250 VICTORIA STREET, WETHERILL PARK – STATE SIGNIFICANT DEVELOPMENT APPLICATION – SSD - 15221509

I refer to the above State Significant DA submitted by Woolworths for a warehouse and distribution centre at the above site.

Figure 1 – potential operational and construction truck routes

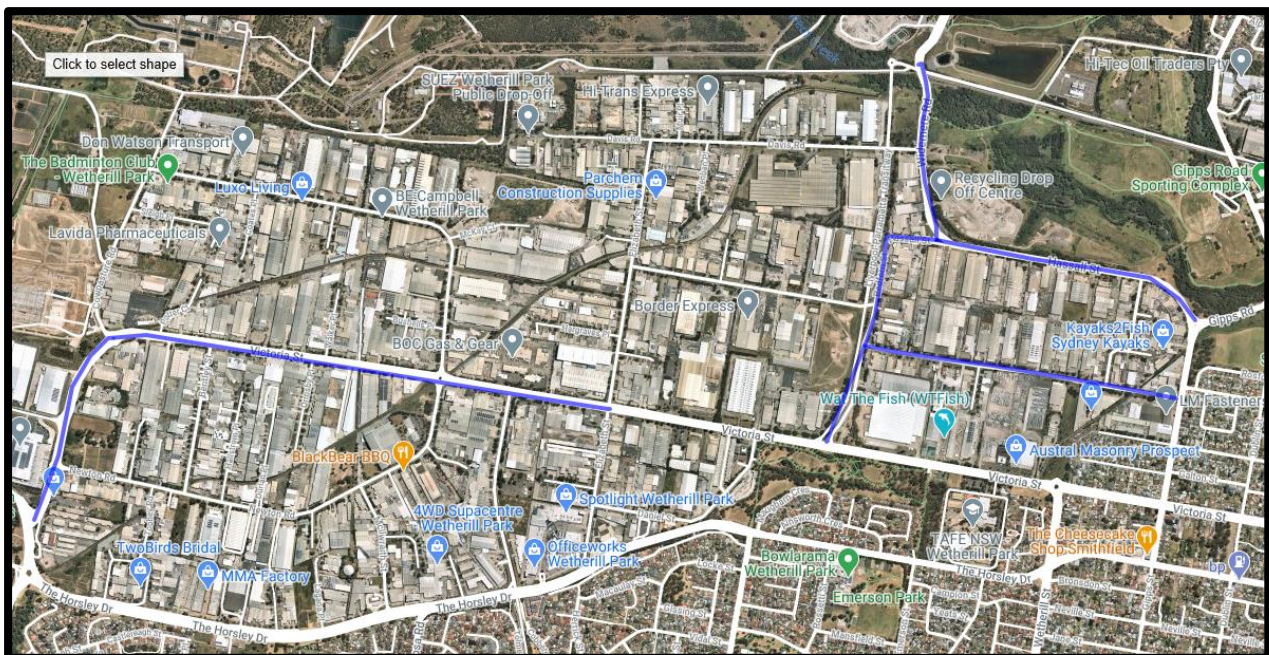
- Extent of any existing damage that would enable any deterioration, during and after construction to be observed. (Please see potential operational and construction vehicle movements below).

Council's Assets Team require the applicant engage an experienced pavement design engineer to assess and provide a report in relation to the impact of the proposal on existing road pavement and existing drainage structures such as stormwater pipes, pits culverts and bridges in the surrounding road network for heavy vehicle movement during the construction phase of the project.
